Report to ACRS

LONG ISLAND LIGHTING COMPANY

Shoreham Nuclear Power Station

Division of Reactor Licensing
U. S. Atomic Energy Commission

FIGURE A-2

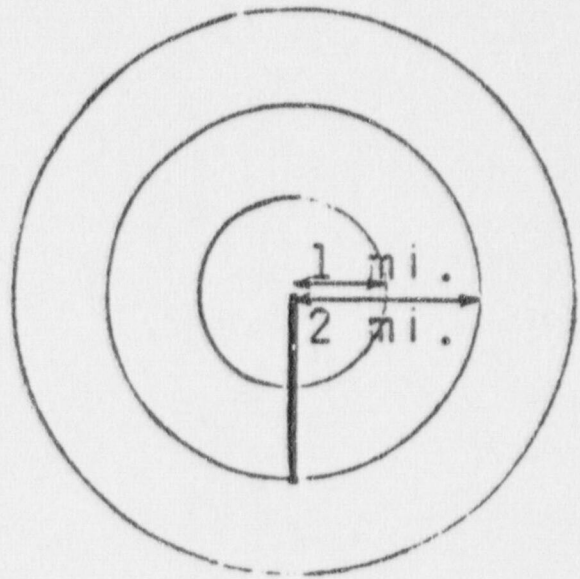
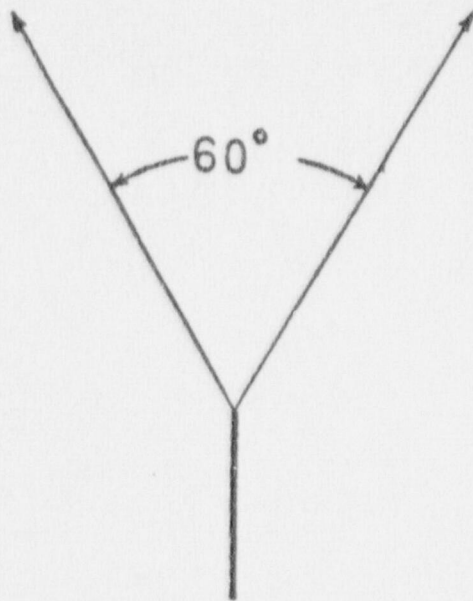
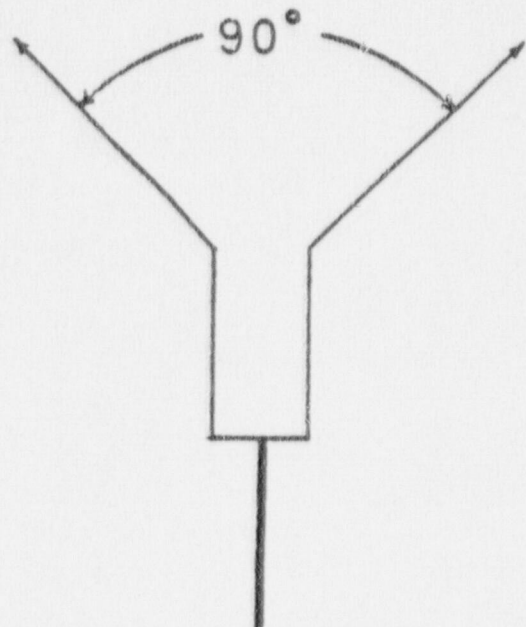
We calculated the variation of crash probability with distance by using several different geometries. We considered concentric circles around the airport, neglecting runway orientation; we considered a 60° fan-shaped path symmetric about the extended centerline of the runway, and we considered a path one mile wide for the first two miles opening into a 90° angle at the two-mile distance (see Figure A-2). The normalized plots of the crash probabilities for these three geometries as well as for the applicant's geometry are shown in Figure A-3. For all geometries we have essentially the same exponentially-shaped curves. The general appearance of such an exponential

FIGURE A-5

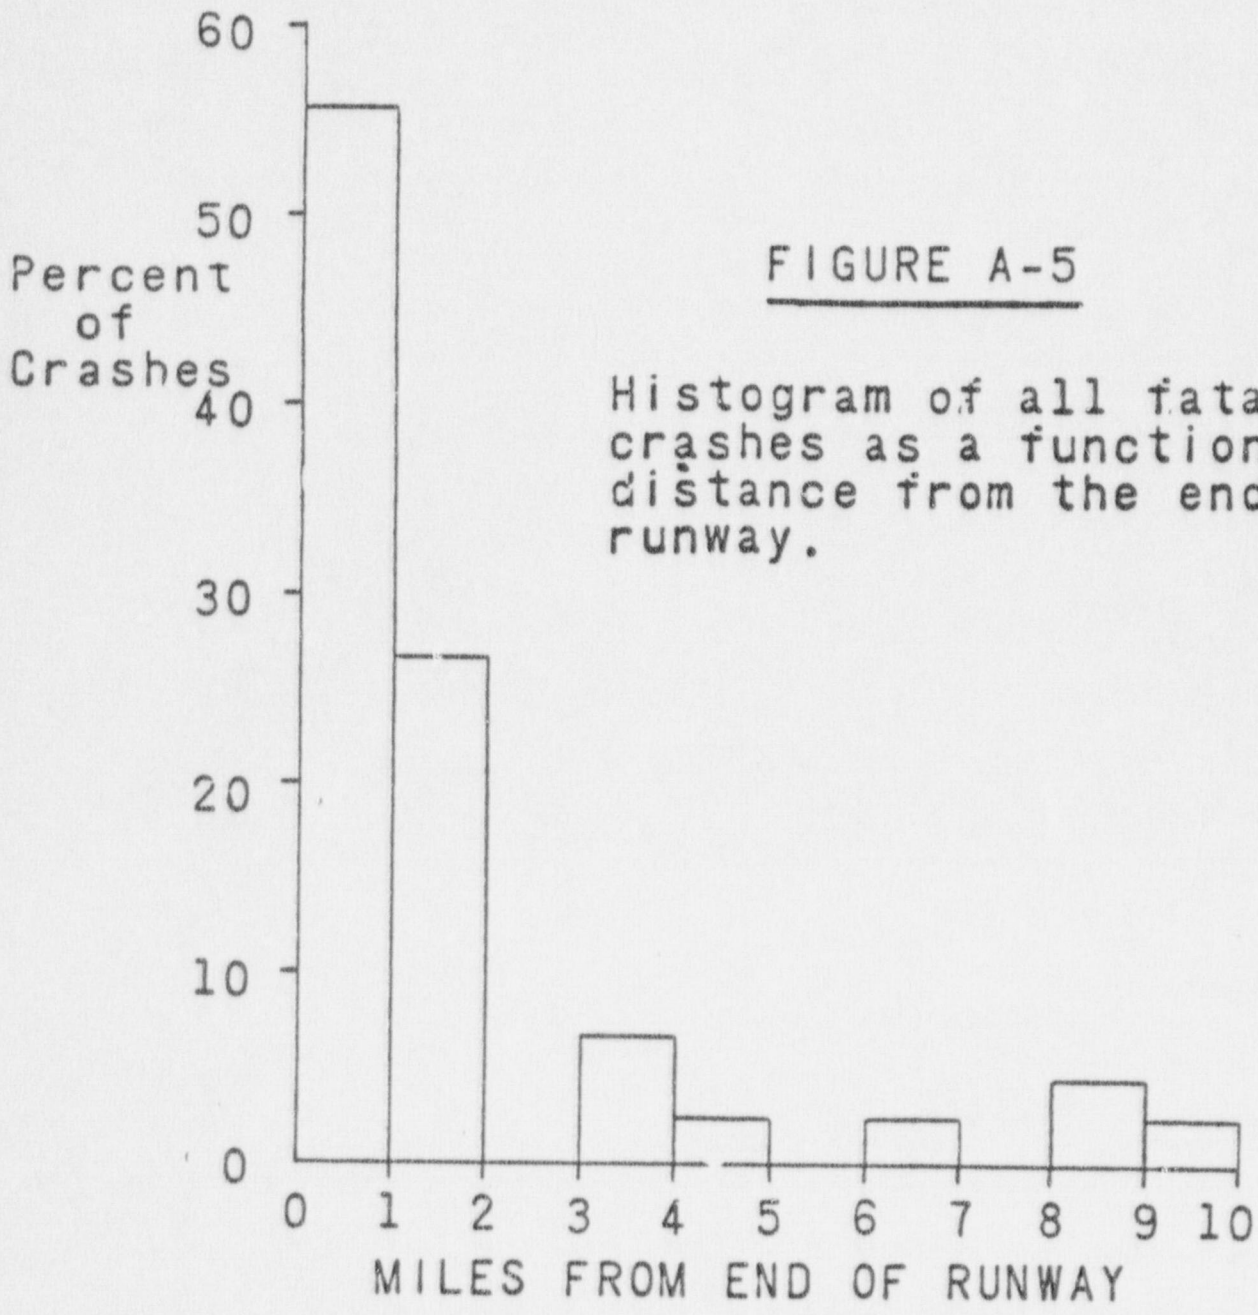
The same effect can be seen on Figure A-5 which is a histogram of the percent of fatal crashes which occurred at various distances (out to ten miles) from airports over a ten-year period. These data were analyzed for the specific geometry of the runways at the Peconic River Airport near the proposed Shoreham Plant, but the general shape of the crash-distribution histogram would not change significantly for other runway configurations. One crash is equivalent to 2.2% on the graph.

As shown in Figure A-5, 85% of the crashes which occurred within ten miles of an airport occurred within two miles of the airport. Crashes which occurred on the airport were excluded. Seven percent occurred between two and four miles and each additional mile thereafter adds about two percent.

As a result of our examination of the histogram (Figure A-5) and the crash probability data (Figures A-3 and A-4), we conclude that there is little change in the crash probability after about two miles regardless of the method of analysis used. We note, however, that there is a sharp increase in crash frequency within the two-mile distance.
